Transport Statement

Land at Bridge Cottage and The Old Cottage, A29 Lidsey Road, Lidsey

February 2018

Stage 1 Road Safety Audit

SITE ACCESS LAYOUT PLAN – DESIGN_SGR_110216_V5

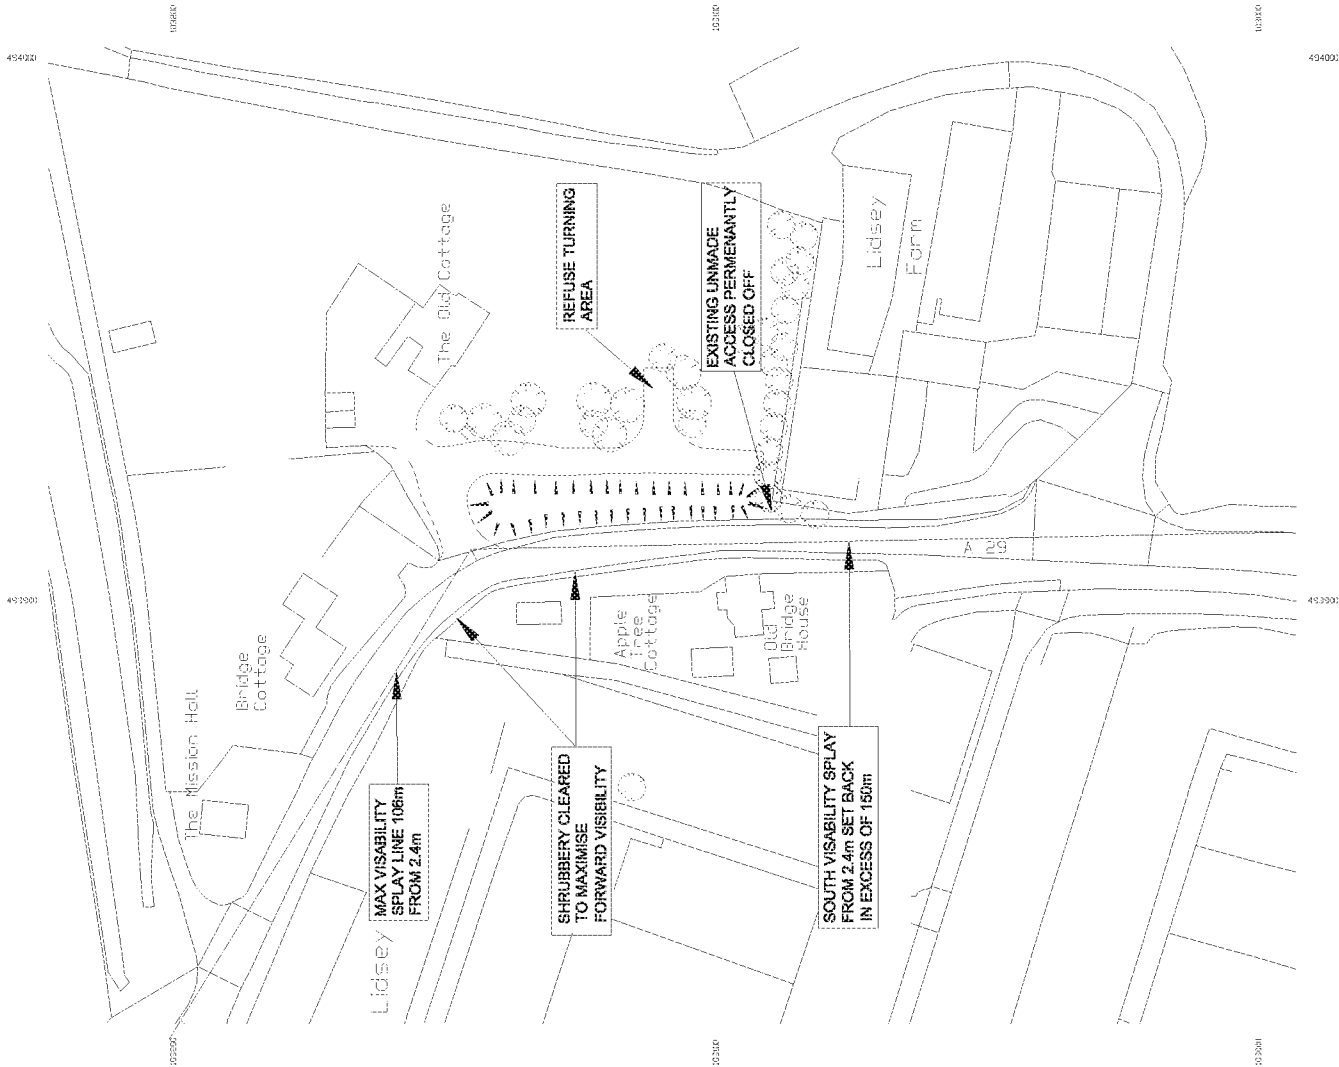
No further comment needed with respect to the design. However the highway authority must be prevailed upon to remove the overhanging branches, shrubbery and undergrowth and to establish a maintenance regime that will ensure such growth does not recur.
